# Access Compliance Report

## Public Rights-of-Way (Curb Ramps)

Intersection ID: 52442	Main Street: WOODWARD_AV	Cross Street: BENDING_BIRCH_PL	Location: SE
ADA ID: 3E1CE0695115	Ramp Type: Directional1	Initial Pass/Fail: Fail	Overall Compliance: No
Severity Score: 13.75			
Codes/Mitigation Info/Possible Solution		Field Measurements/Component Compliance

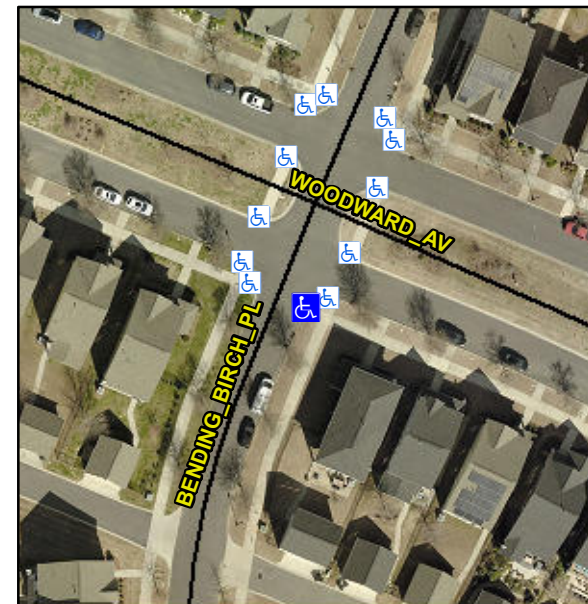
**R304.2.2, R304.5.3**

Compliance	Description	Data	Compliance	Description	Data
N/A	Ramp Length (in)	<b>79.0</b>	N/A	Grade Break?	<b>N/A</b>
Yes	Ramp Width (in)	<b>59.5</b>	N/A	Grade Break Slope (%)	<b>0.0</b>
No	Ramp Slope (%)	<b>9.7</b>	N/A	Grade Break XSlope (%)	<b>0.0</b>
No	Ramp XSlope (%)	<b>5.0</b>			
N/A	Flare Type LT	<b>N/A</b>	N/A	Flare Type RT	<b>N/A</b>
N/A	Flare Slope LT (%)	<b>N/A</b>	N/A	Flare Slope RT (%)	<b>0.0</b>
N/A	Flare Traversable LT?	<b>N/A</b>	N/A	Flare Traversable RT?	<b>N/A</b>
N/A	Landing Length (in)	<b>0.0</b>	N/A	DWS Provided?	<b>N/A</b>
N/A	Landing Width (in)	<b>0.0</b>	N/A	DWS Contrast?	<b>N/A</b>
N/A	Landing Slope (%)	<b>0.0</b>	N/A	DWS Length (in)	<b>N/A</b>
N/A	Landing X Slope (%)	<b>0.0</b>	N/A	DWS Full Width?	<b>N/A</b>
N/A	Landing Curb? (Y/N)	<b>N/A</b>	N/A	DWS Offset LT (in)	<b>N/A</b>
N/A	Shared Landing?	<b>N/A</b>	N/A	DWS Offset RT (in)	<b>N/A</b>
N/A	Gutter Ponding?	<b>0.0</b>	N/A	Gutter Slope (%)	<b>N/A</b>

N/A	Gutter Lip Ht (in)	<b>3.0</b>	N/A	Gutter X Slope (%)	<b>N/A</b>
N/A	Painted X Walk1?	<b>No</b>		Road Slope (%)	<b>0.5</b>
	X Walk 1 Direction	<b>To W</b>		Road X Slope (%)	<b>4.2</b>
	X Walk 1 Width (in)	<b>N/A</b>		Clear Space?	<b>N/A</b>
	X Walk 1 Slope (%)	<b>0.5</b>	N/A	Clear Space to XWalk (in)	<b>N/A</b>
	X Walk 1 X Slope (%)	<b>4.2</b>	N/A	Storm Grate/Utility Hazard?	<b>N/A</b>
N/A	Ramp inside XWalk1?	<b>N/A</b>		Storm Grate/Utility Type	
N/A	Any Obstructions?	<b>N/A</b>			<b>N/A</b>
	Obstruction Type		Yes	Surface Condition? (G/P)	<b>Good</b>
			N/A	Curb Slope (%)	<b>12.7</b>

**Remove & Replace Entire Ramp.**
